**MEETING OF THE
PLANNING AND ZONING BOARD
QUASI-JUDICIAL PUBLIC HEARING**

May 21, 2019

**TOWN OF BAY HARBOR ISLANDS
DRC STAFF
PLAN REVIEW**

**RE: BELIZA 1170 102 STREET
RESPONSE TO COMMENTS BY MICHAEL MILLER PLANNING ASSOCIATES, INC.**

P & Z PROPOSED REVISION

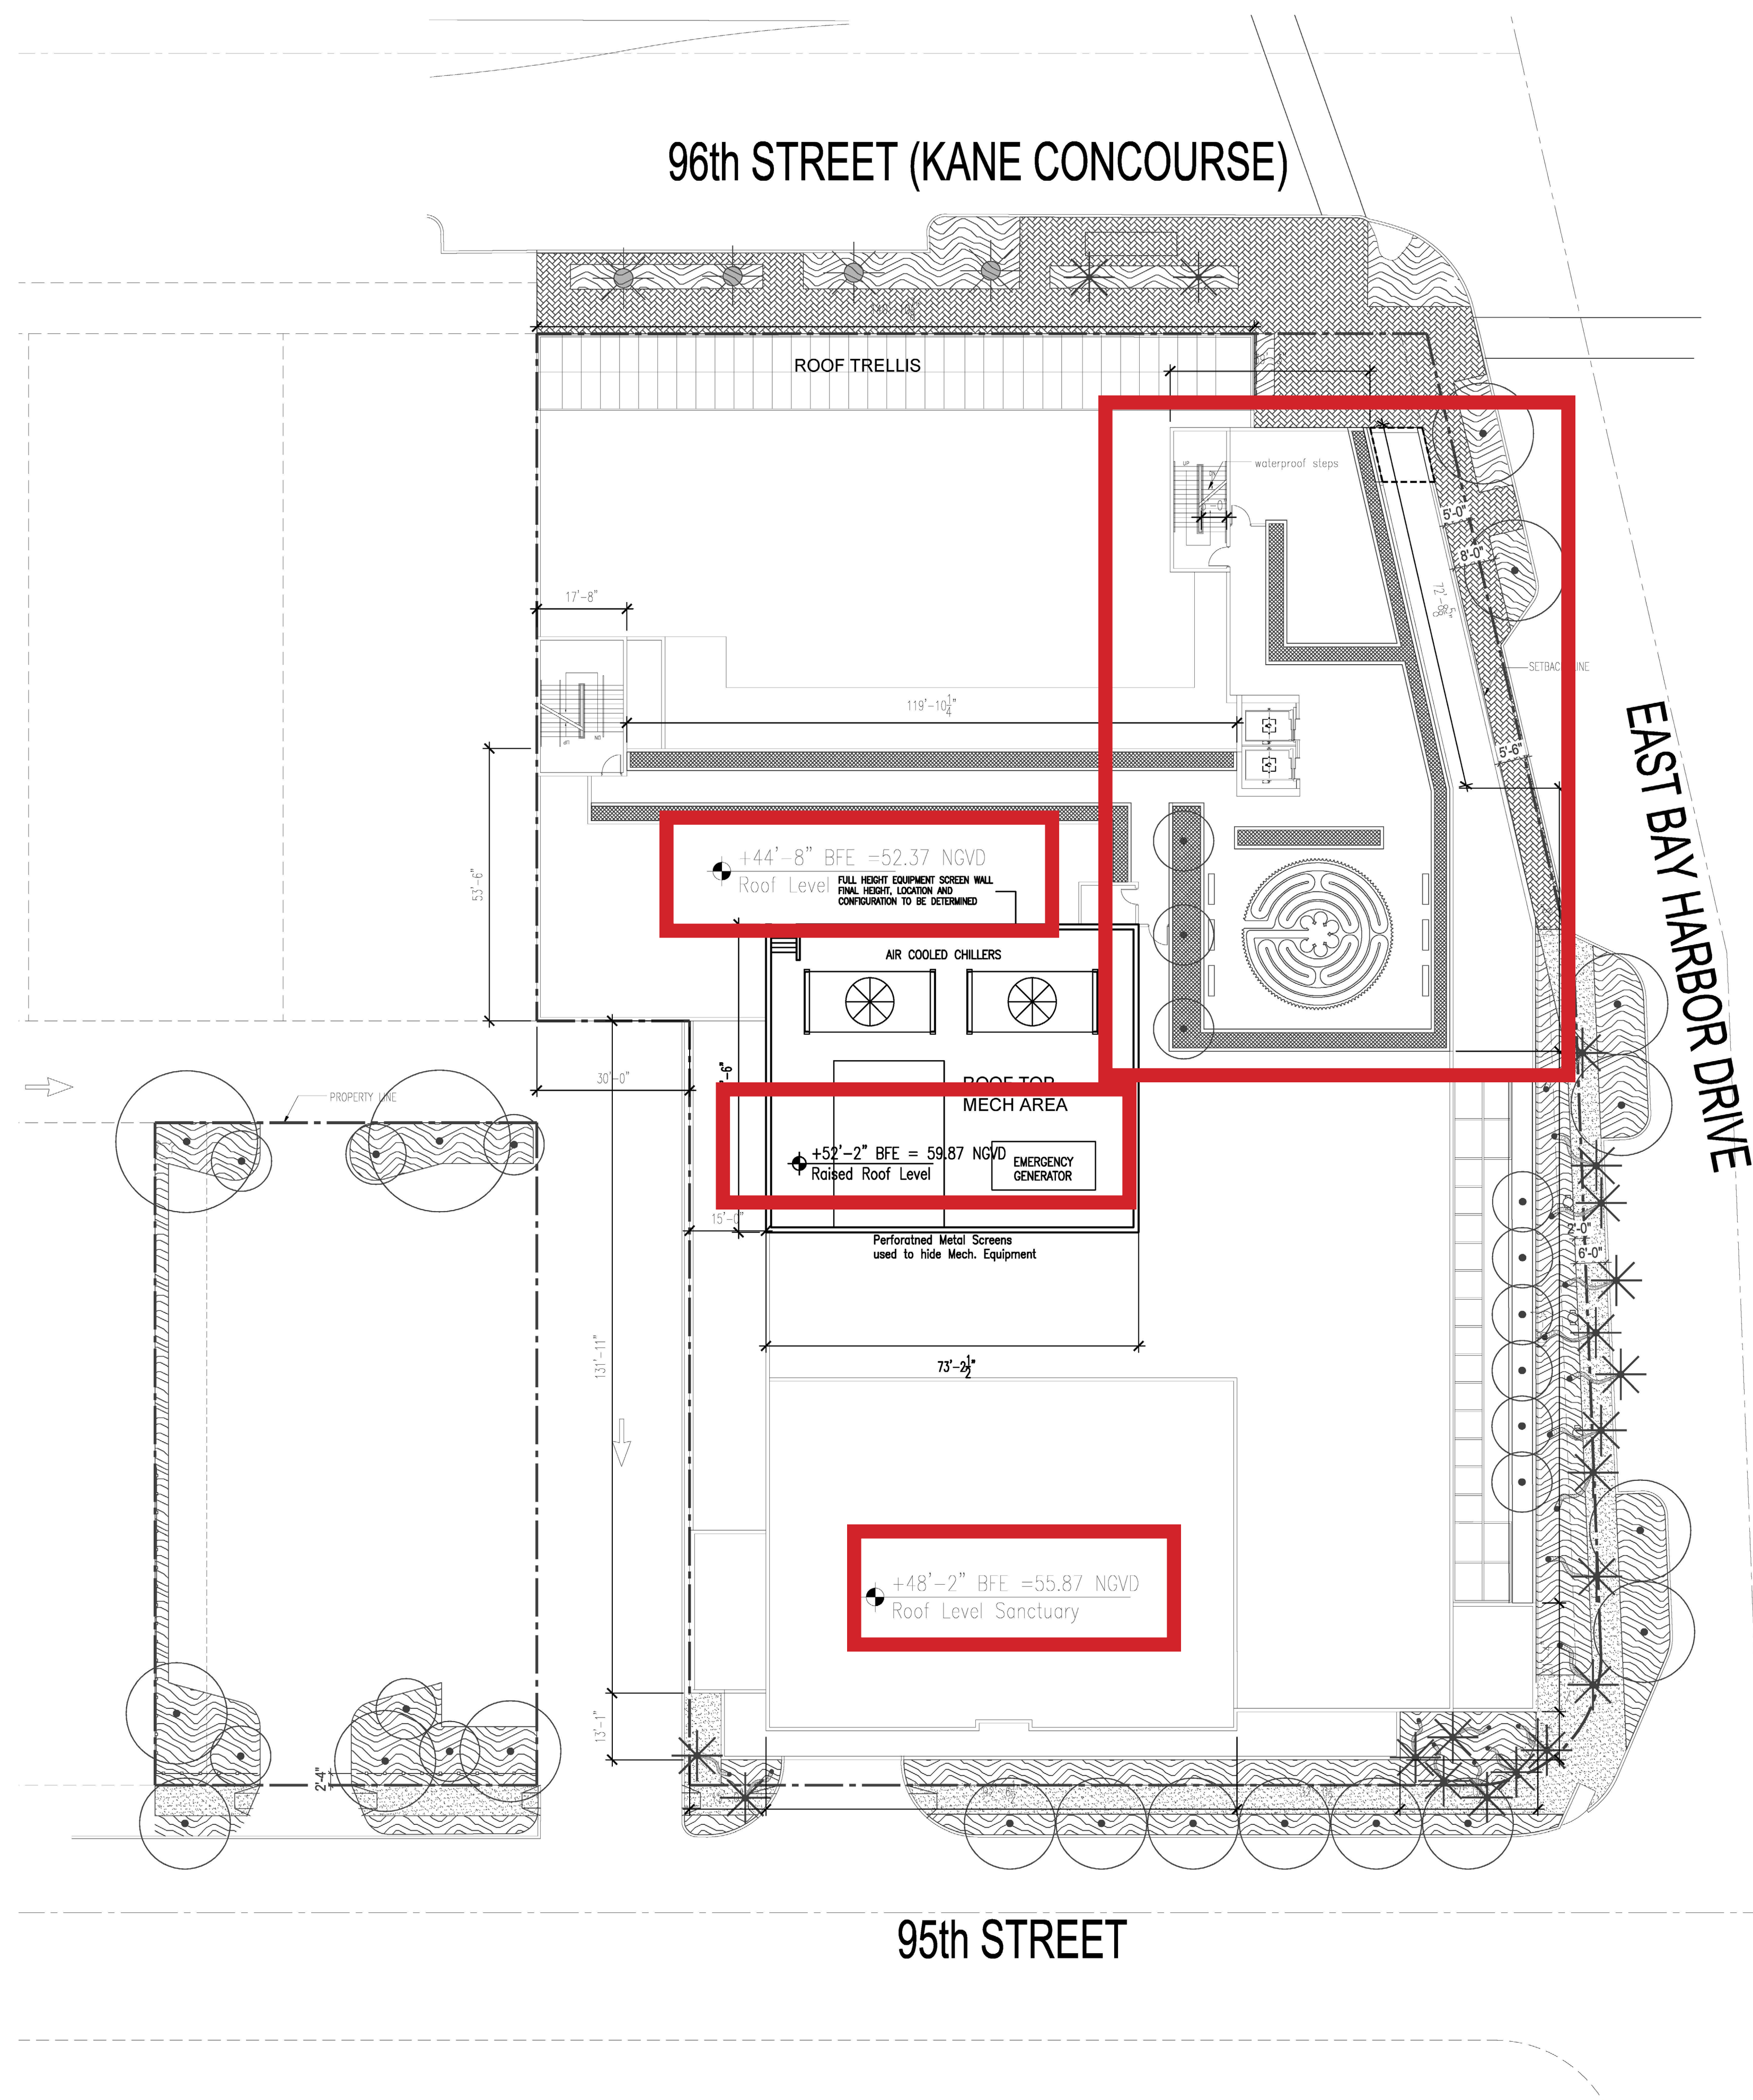
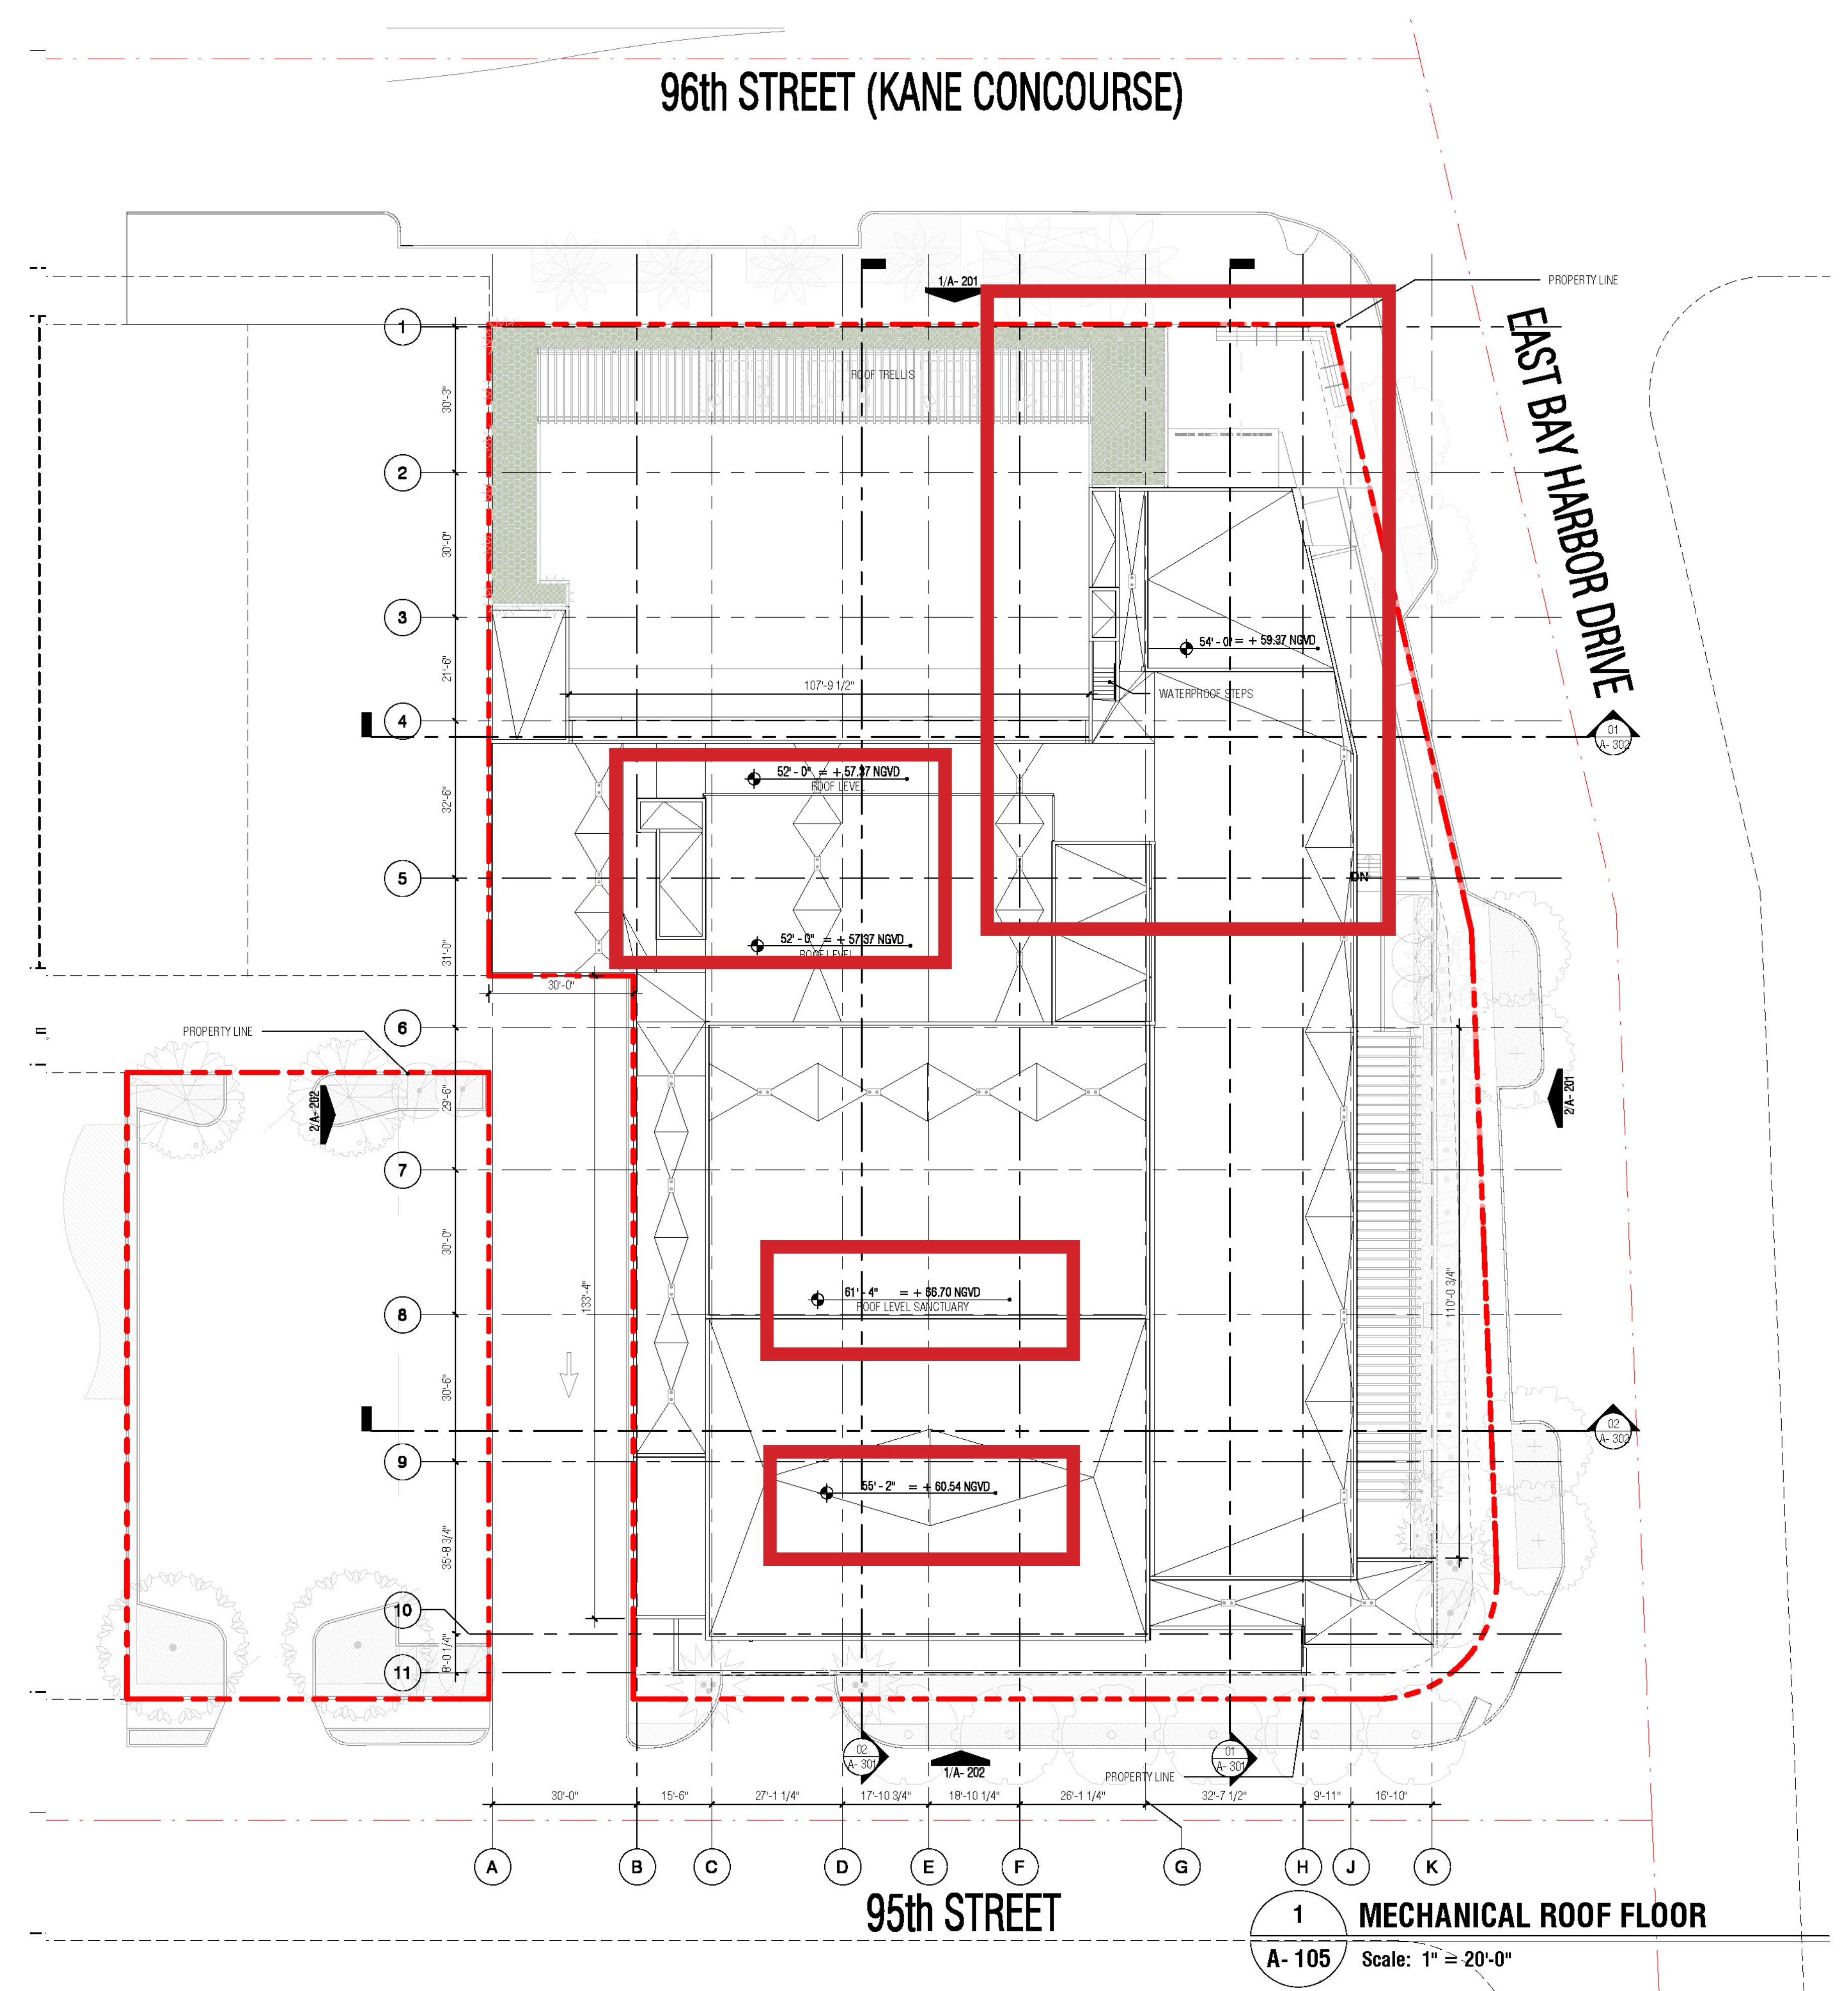
REMOVAL OF ROOF GARDEN ; ADDITIONAL HEIGHT ON ROOF OF SANCTUARY AND CHAPEL;

P & Z PROPOSED REVISION EAST-WEST SECTION 1

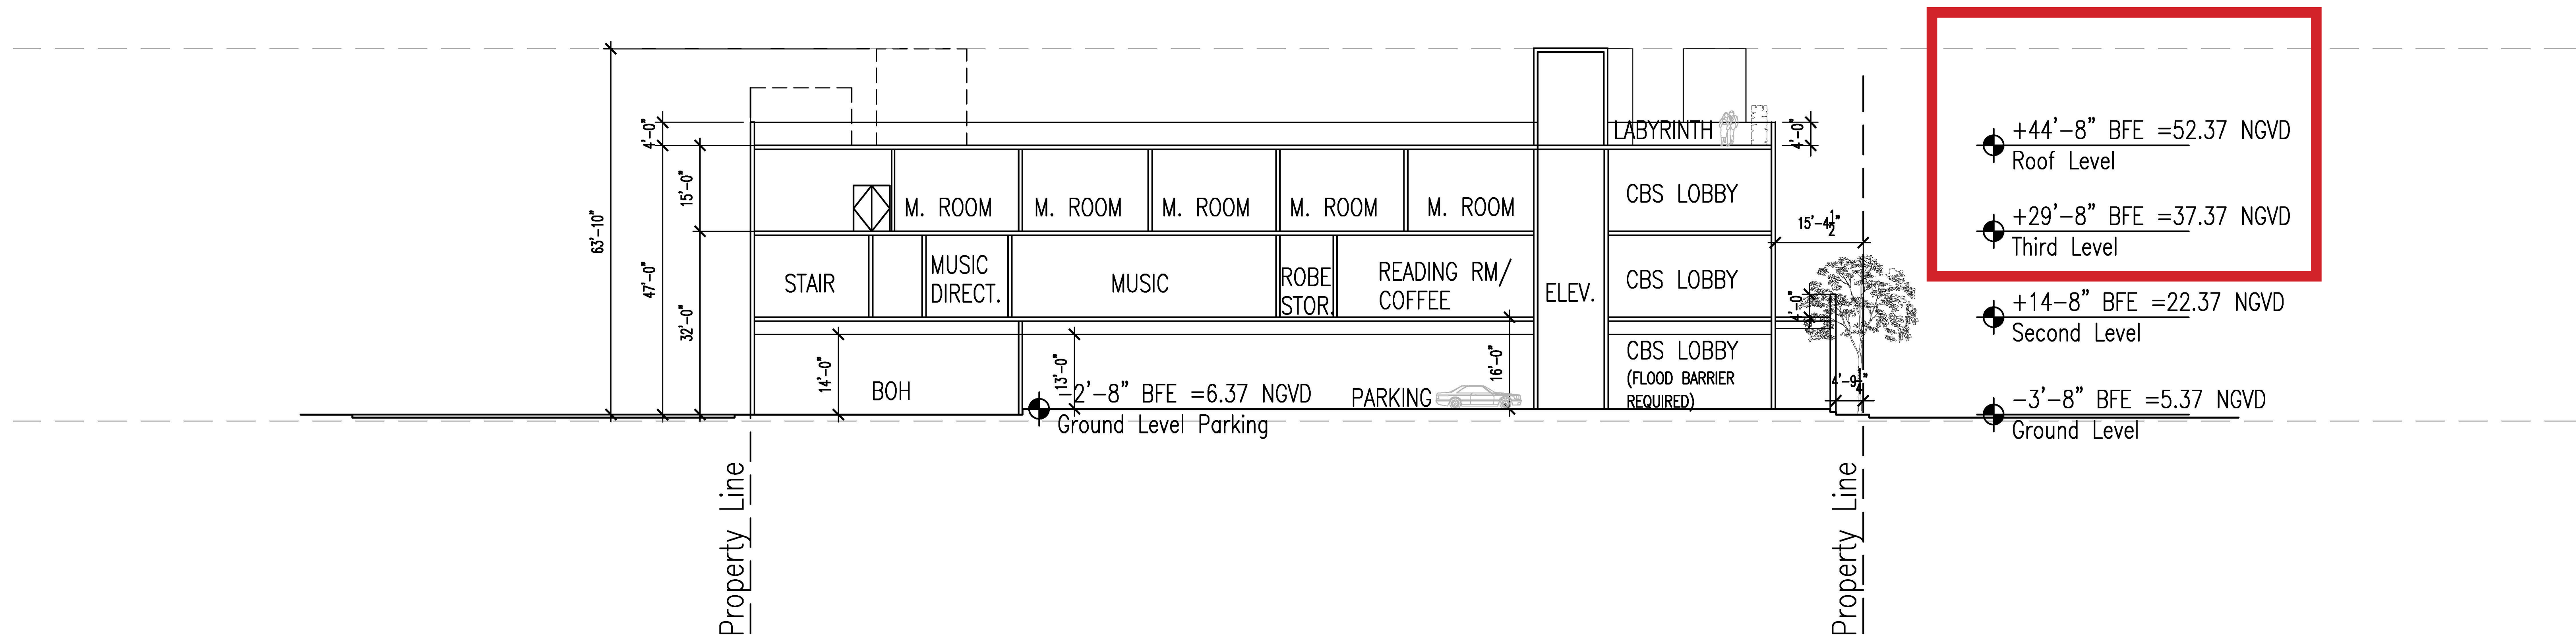
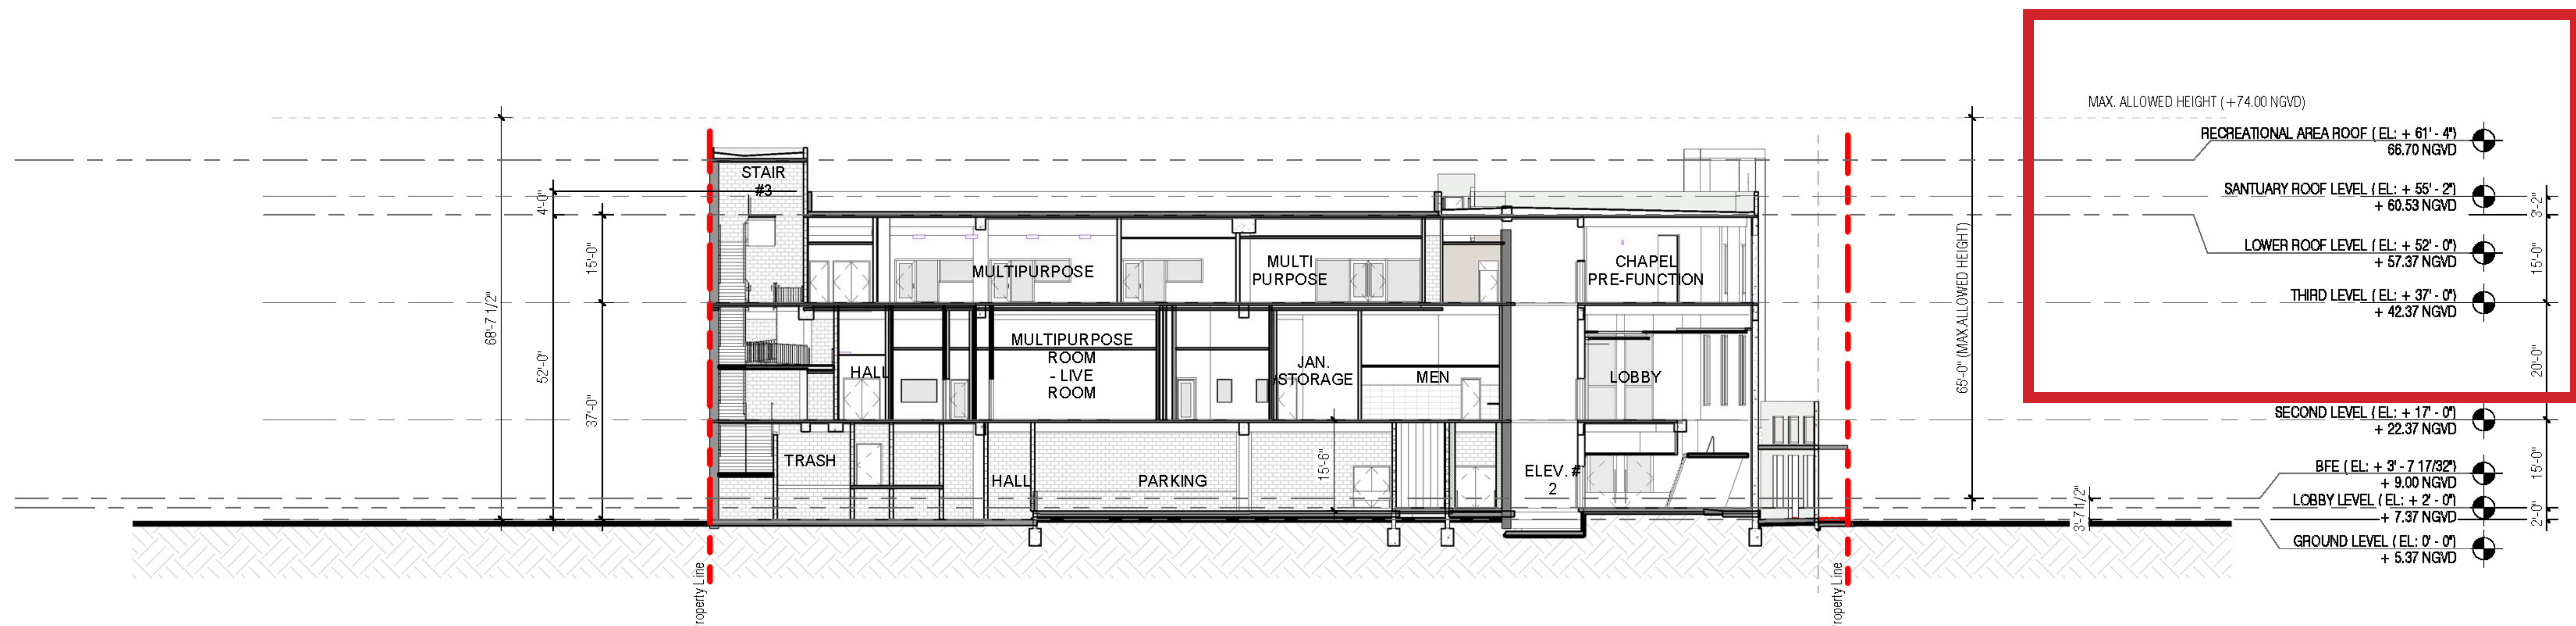
ADDITIONAL HEIGHT ON SECOND FLOOR/ SANCTUARY; LANDSCAPE NOT SHOWN IN PROPOSED SECTIONS
